Lehi City Council Meeting
Agenda
February 23, 2021

4. Consideration of Preliminary subdivision review of Holbrook Farms Plat I, a five-lot commercial subdivision located at 3600 West and Waterbury Drive (tabled from the February 9th meeting).
   Petitioner: Boyer Company
   Holbrook Farms Plat I Preliminary and Final Subdivision DRC 01.20.21.docx
   Holbrook Farms Plat I Preliminary Subdivision - narrative.pdf
   Holbrook Farms Plat I Prelim Subdivision - plans.pdf
   Holbrook Farms Plat I Prelim Subdivision - traffic report.pdf
   Holbrook Farms Plat I Prelim Subdivision - general plan map.pdf
   Holbrook Farms Plat I Prelim Subdivision - zoning map.pdf
   Holbrook Farms Plat I Prelim Subdivision - aerial map.pdf
   IMG_6330.JPG
   IMG_6331.JPG
   IMG_6329.JPG
   CC Staff Report Holbrook Farms Plat I Preliminary Subdivision 2.23.21.docx

DRC Members Present: Glade Kirkham, Kerry Evans, Greg Allred, Kim Struthers, Gary Smith, Joshua Bunnell, Ross Dinsdale, Trent Dyer
Representatives of the Applicant Present: Eric Winters
Date of Plans Reviewed: 1/12/20
Time Start: n/a
Time End: n/a

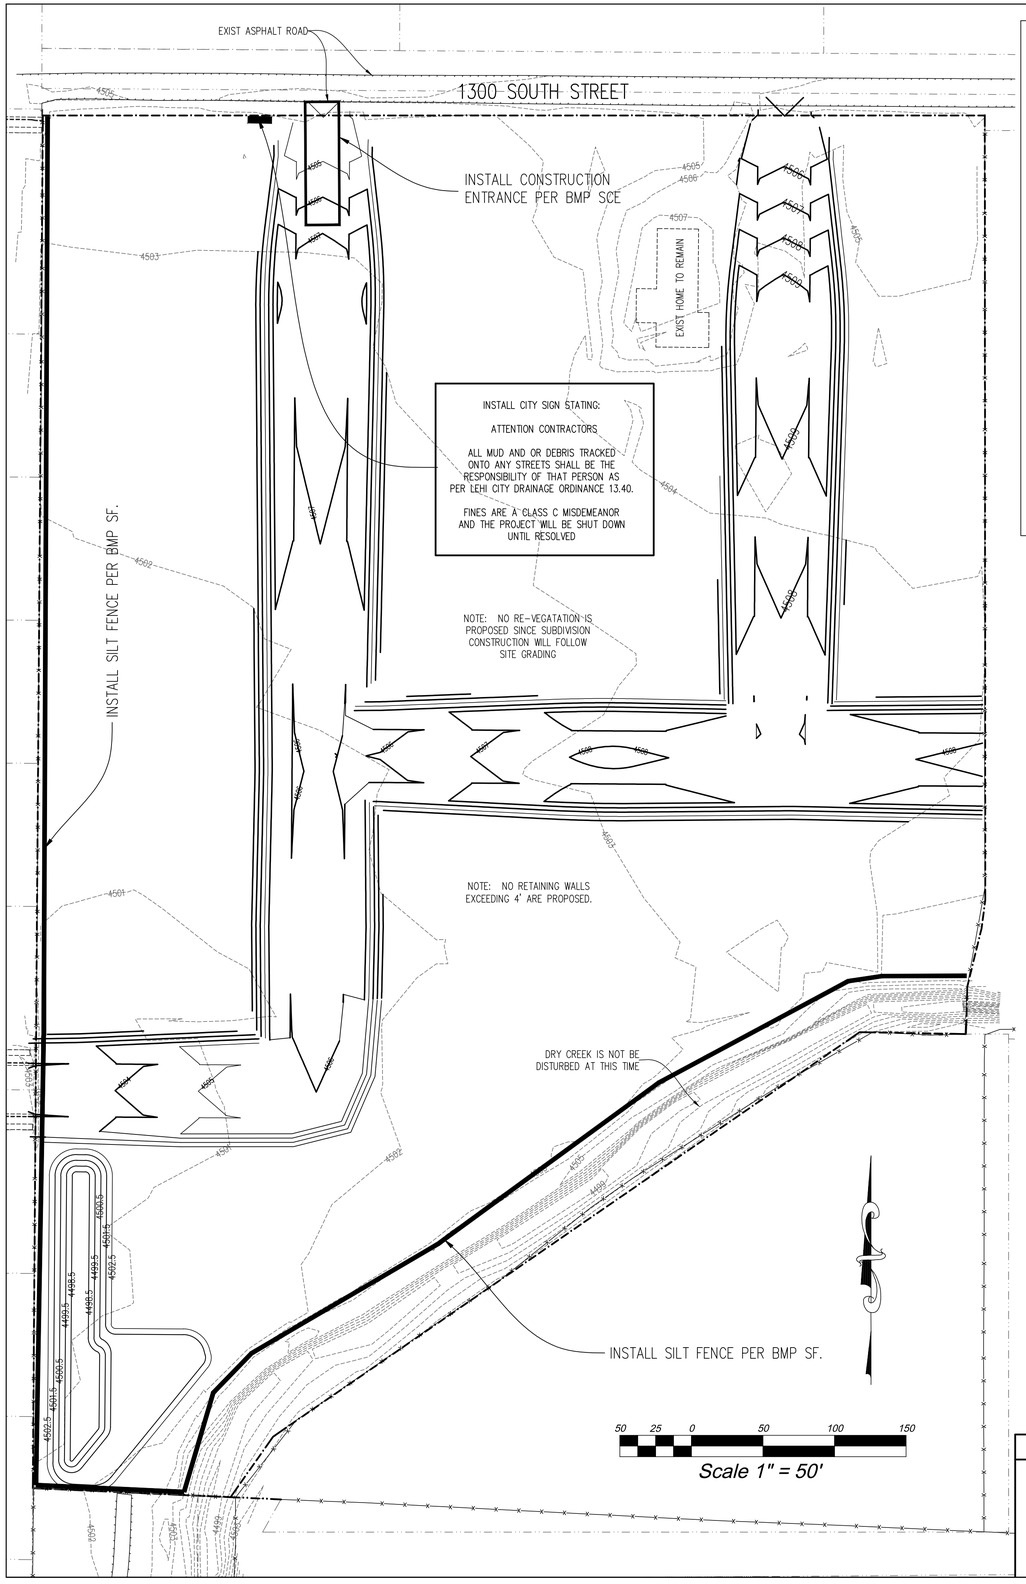
DRC REDLINE COMMENTS:
Glade – Power: No comments
Kerry – Fire: No comments
Greg – Water/Sewer: No comments
Trent – Parks: No comments
Gary – Building/Inspections: No comments
JD – Streets:

1. Add to the plan the cuts and fills through the project.
